UNITED STATES PATENT AND TRADEMARK OFFICE

Office Action Summary

10/632,505

DETAILED ACTION

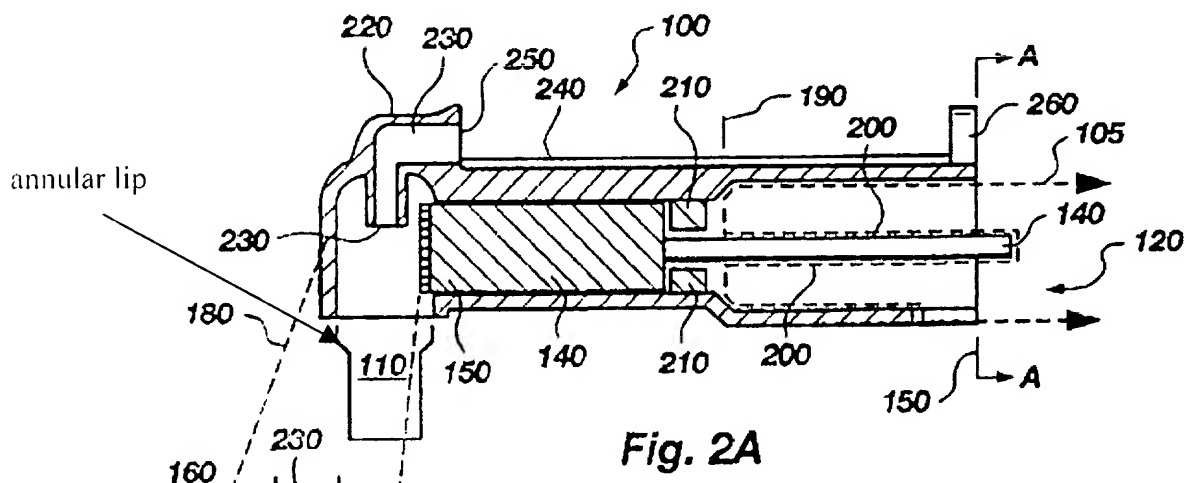
Regarding claims 3, 12, and 21 Figure 2A of the Chipian et al reference (also reproduced below) does show an annular lip "within the inside of the prophy cup" as recited in the claims.
